Revision history: (Compared to ver 2.0A)

Layout Tessolve Date
Date
Date Title CC3101 LP Ver 3.0 REL1 Size A2 Project No <Project Number> Rev B
Scale Date Thursday, January 16, 2014 Sheet 1 of 6

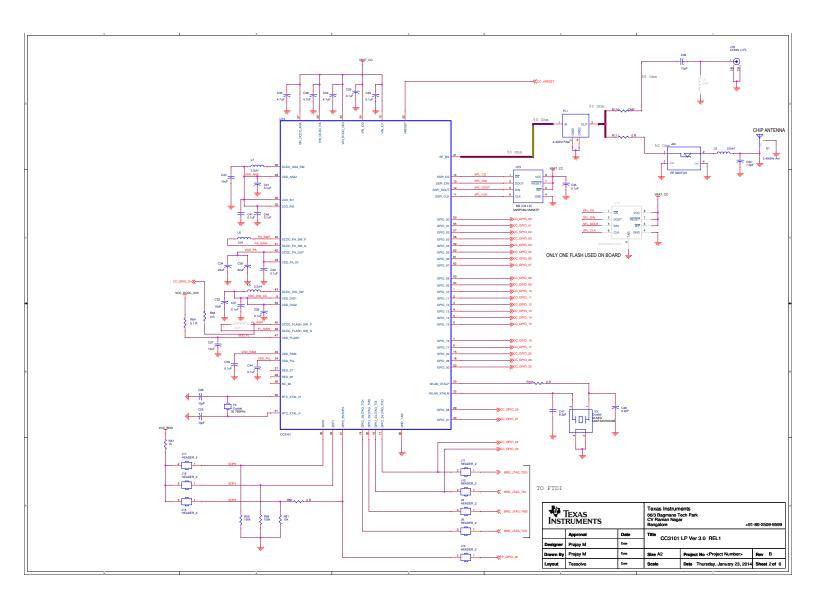
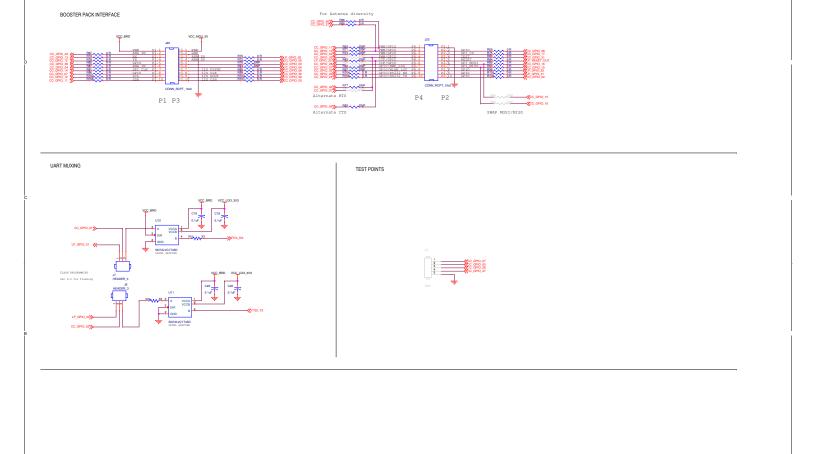
1. Replaced Emualtion circuit with FTDI instead of ICDI
2. Re-arranged the pin assignment of the Pi, P2, P3, P4 to align with the MCU convention.
3. Added pull-down on the LED driver to prevent them from floating.
4. TEXAS INSTRUMENTS Texas Instruments 66/3 Bagmane Tech Park CV Raman Nagar Bangalore Approval
